ADDENDUM

NO. 3

PROJECT NAME: Lehman High School 2025 Additions and Renovations

ADDENDUM DATE: 14 May, 2025

1 FOUNDATION PLAN - AREA E

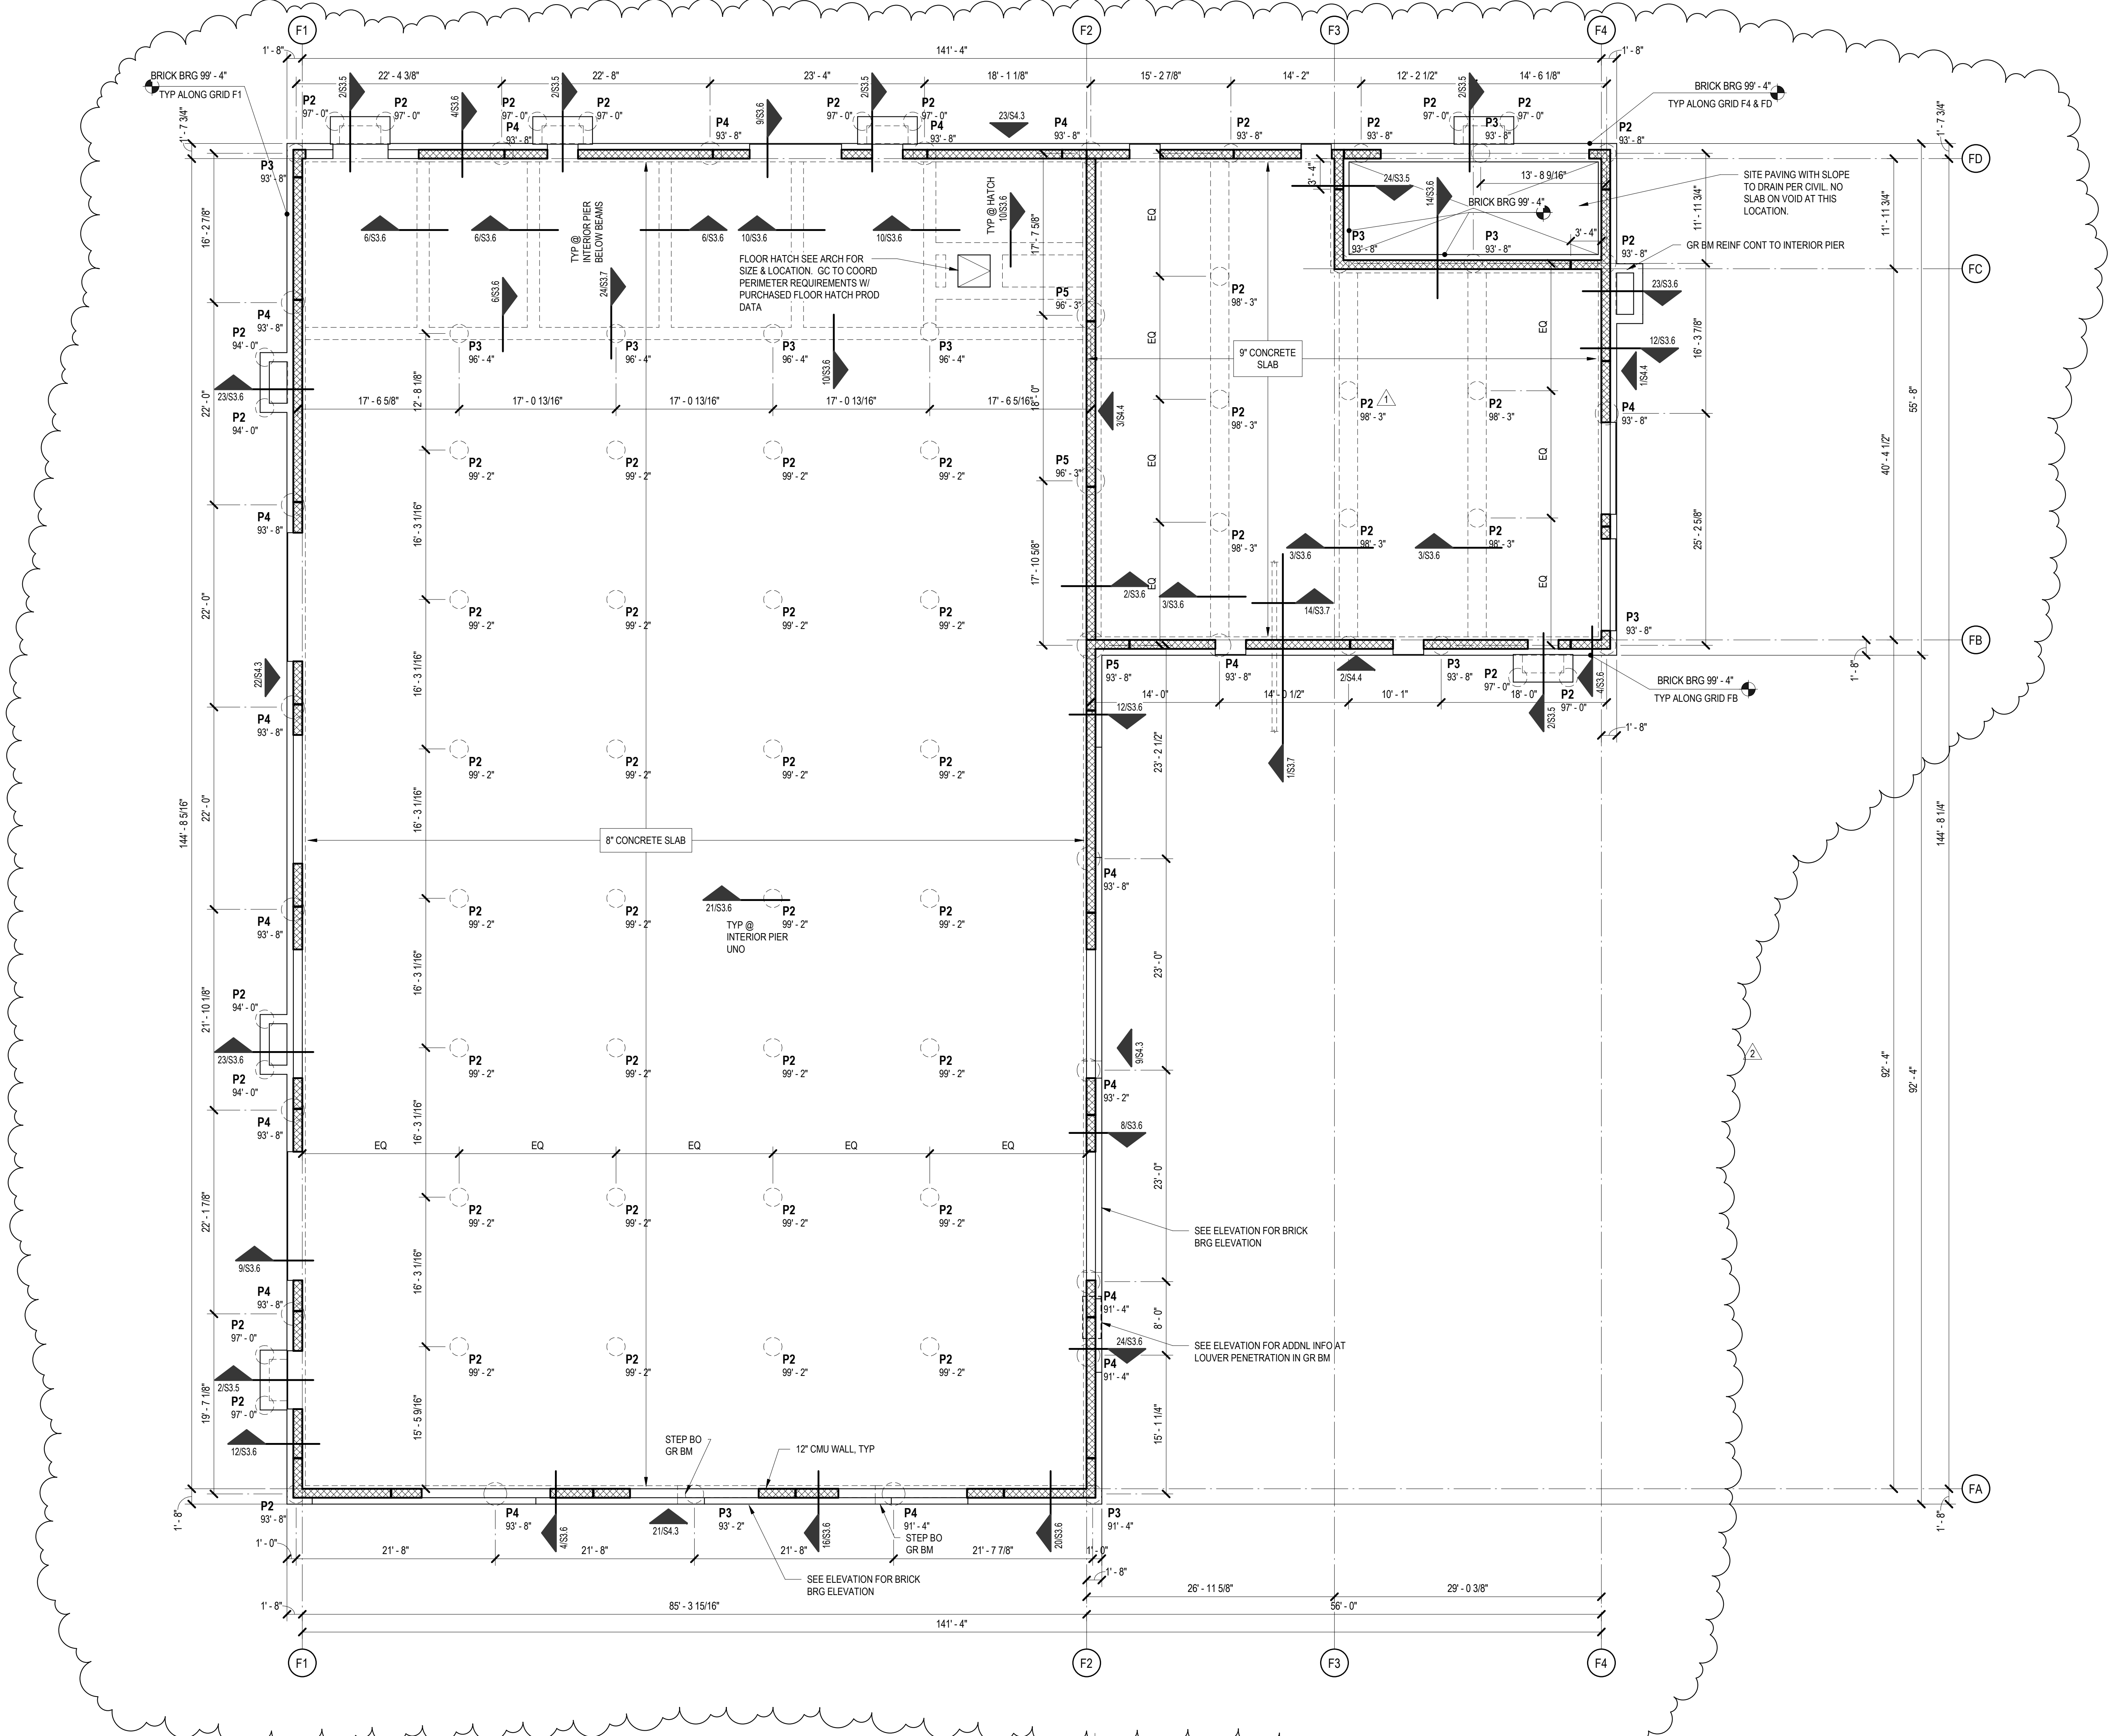
- 1) Revised foundation to concrete flat slab in lieu of composite slab supported by steel beams and girders.
- 2) Added cast-in-place concrete beam where shown.
- 3) Revised pier sizes
- 4) Revised perimeter detailing for slab type

21 AREA E ALONG GRID FA

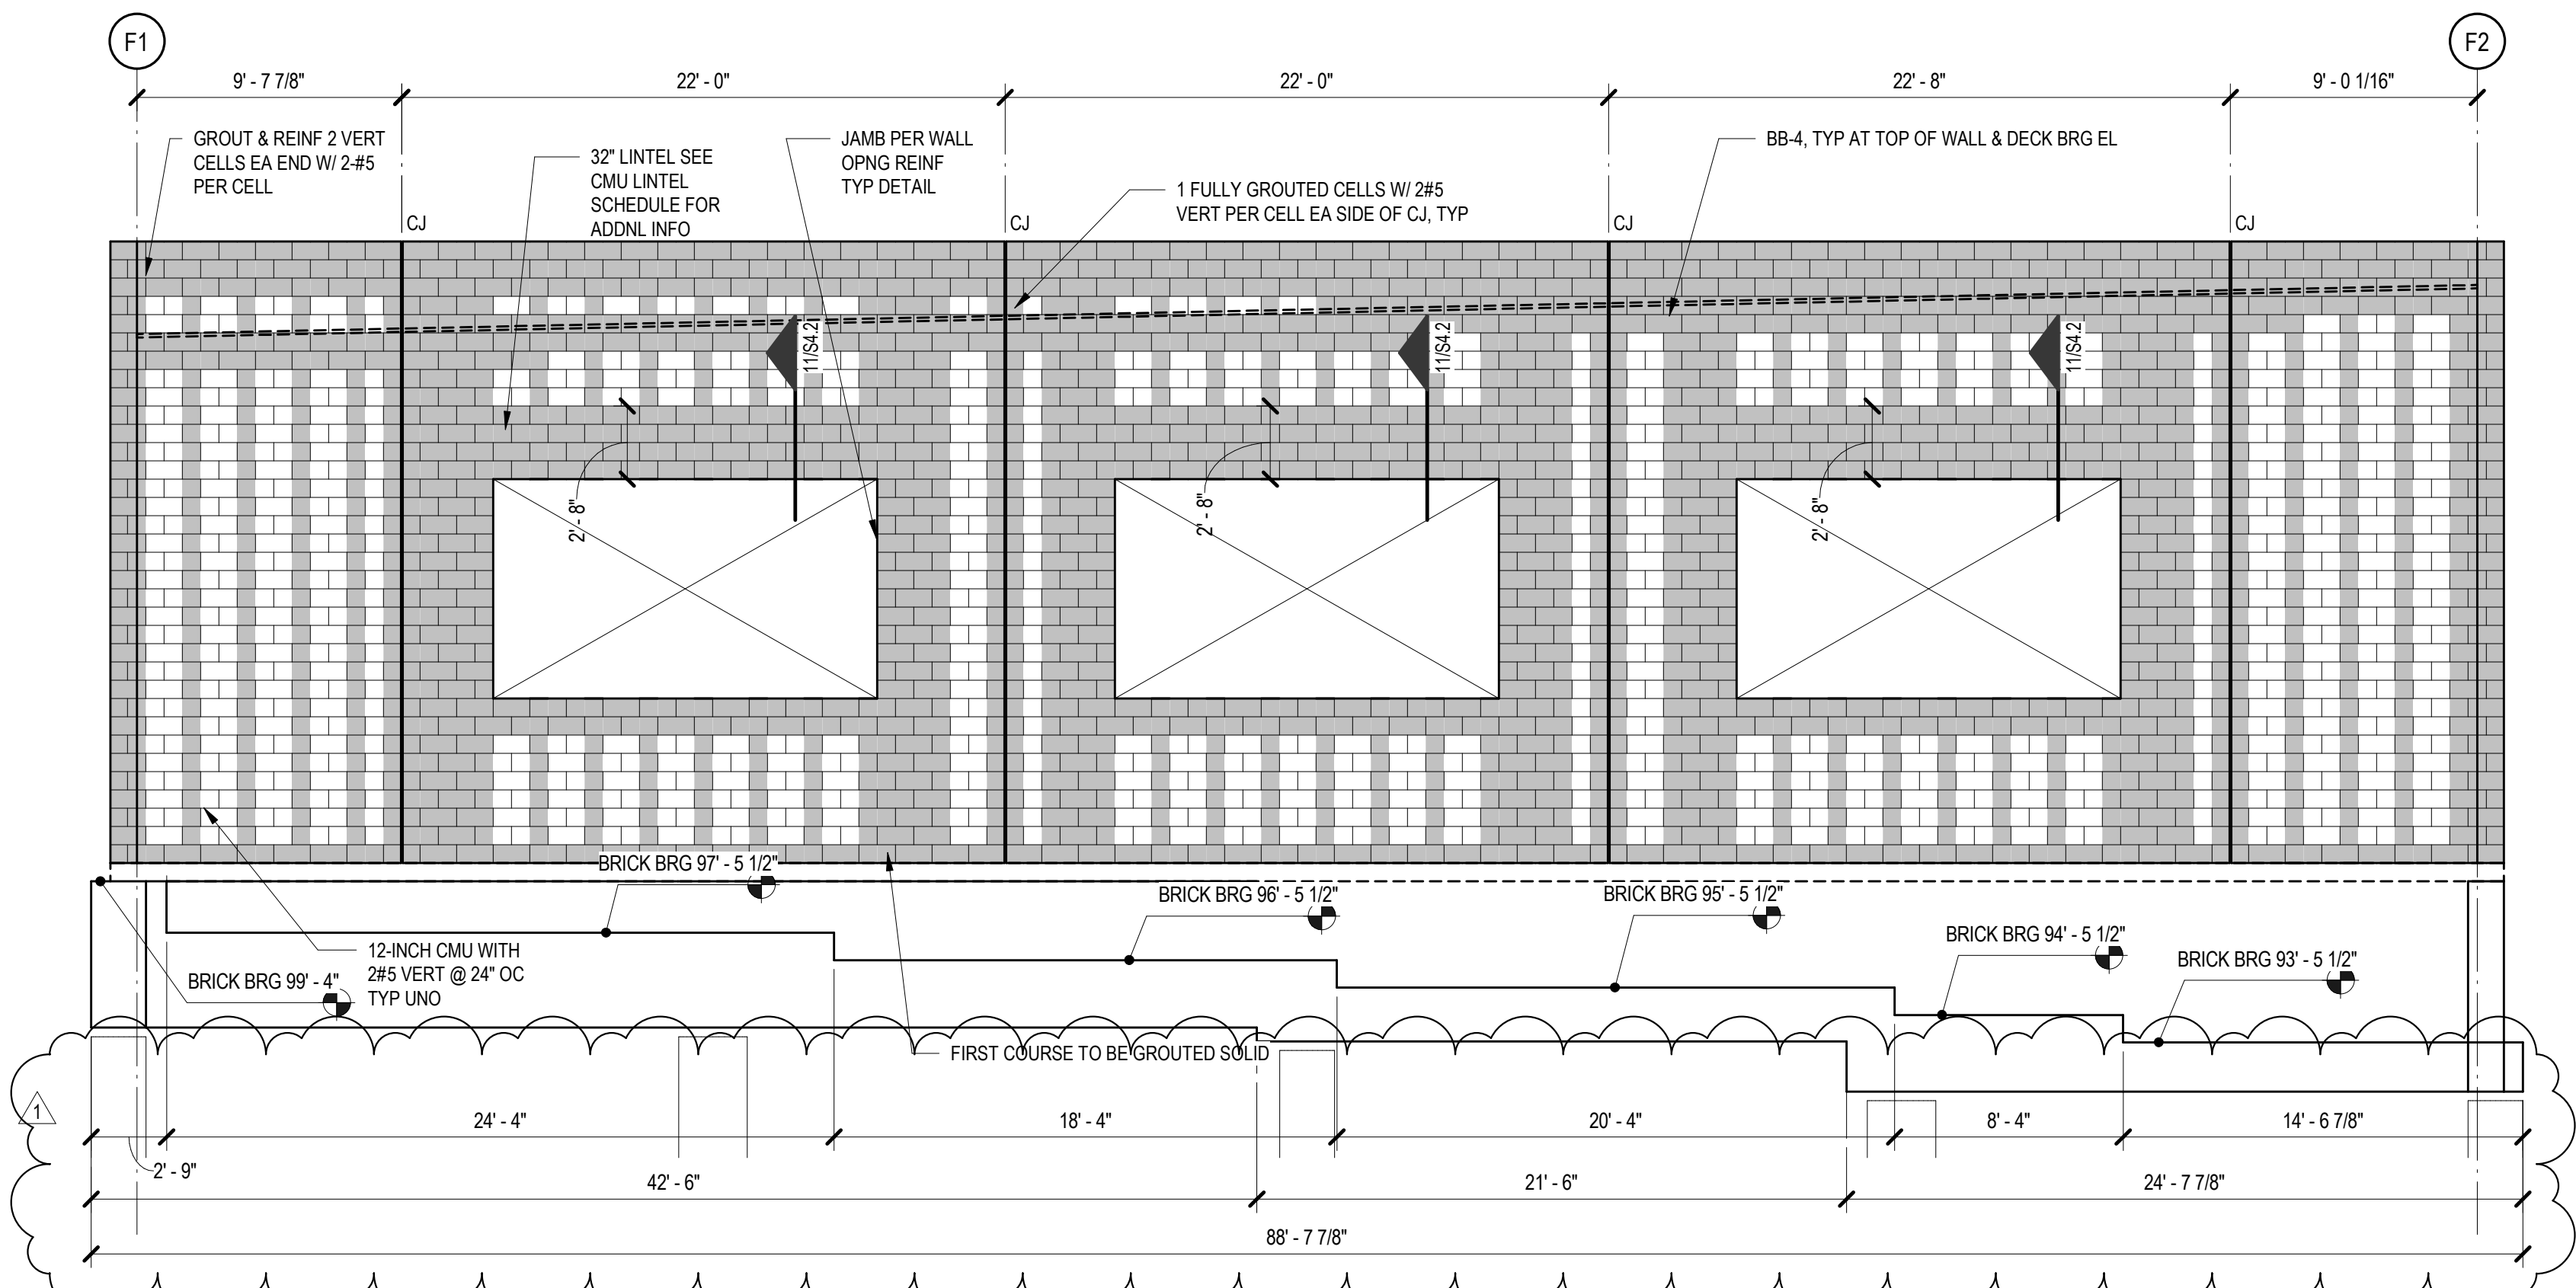
AD No 3, Struct Item 20: **To the Drawings, Sheet S4.3, "MASONRY WALL ELEVATIONS",**
1) Elevation 21 – Dimensions revised

PHASE 3

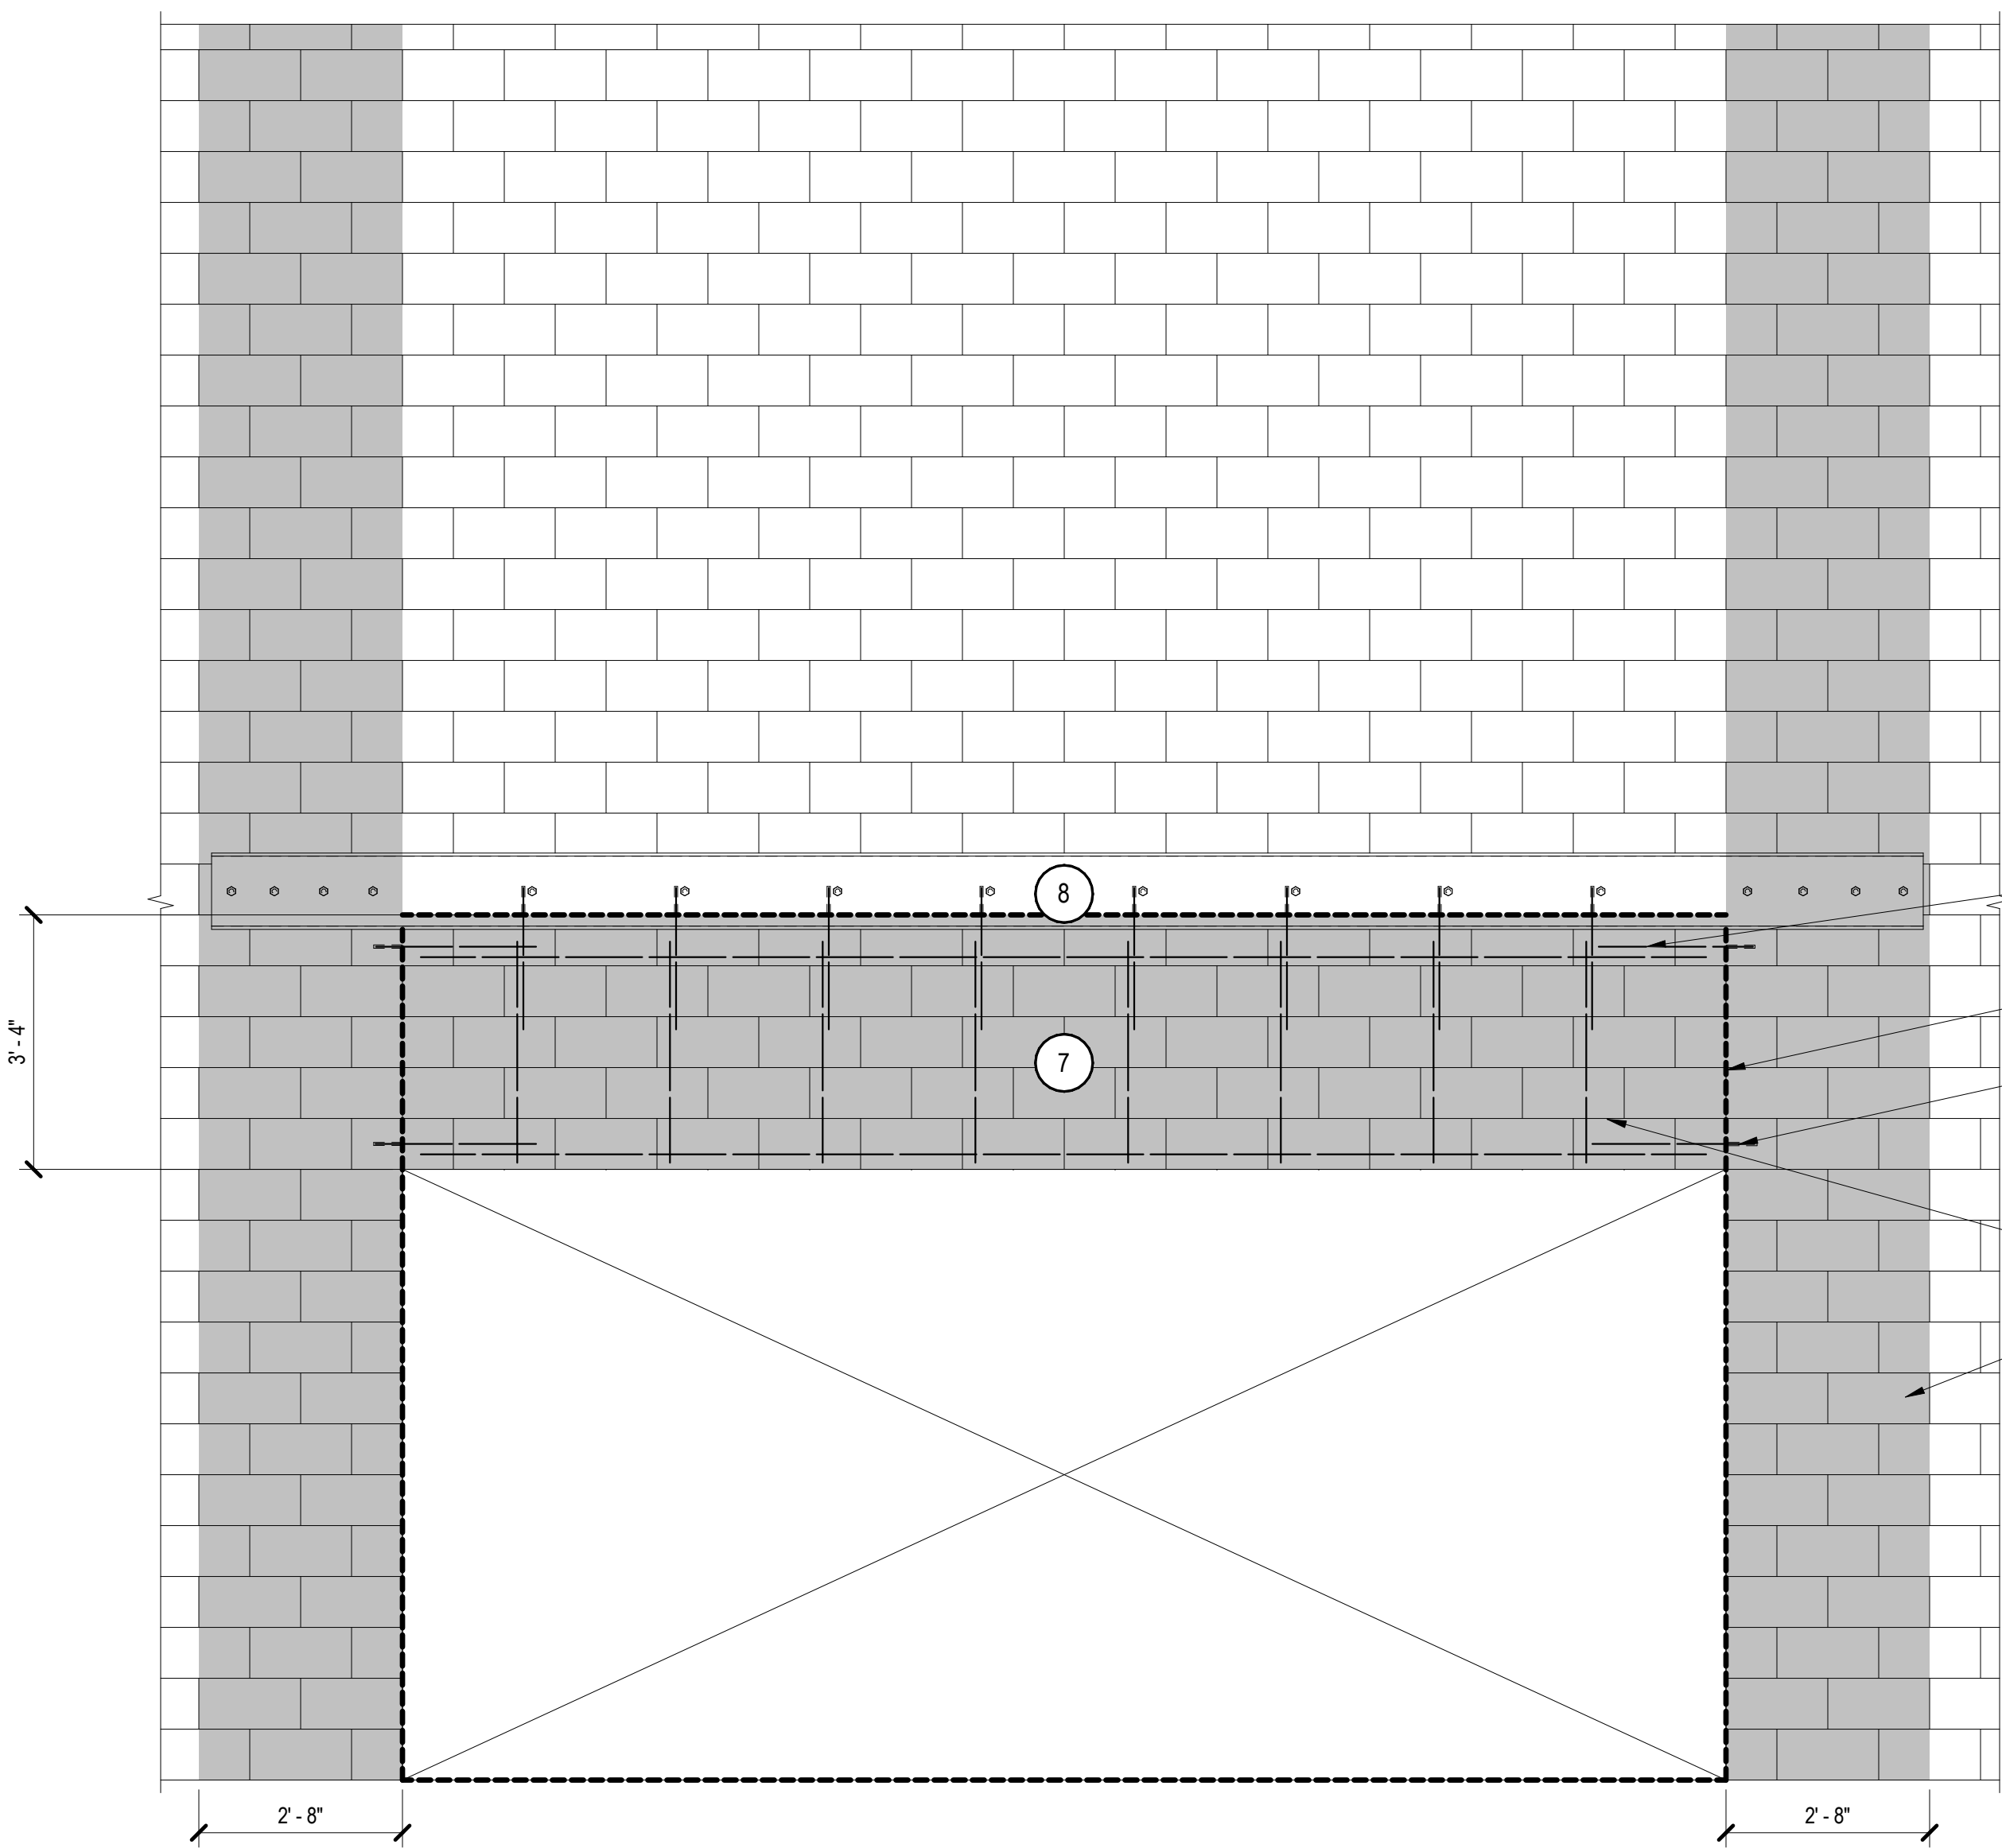
AD No 3, Struct Item 21: **To the Drawings, Sheet S4.7, "MASONRY WALL ELEVATIONS",**
1) Phase 3 – Revised notes.
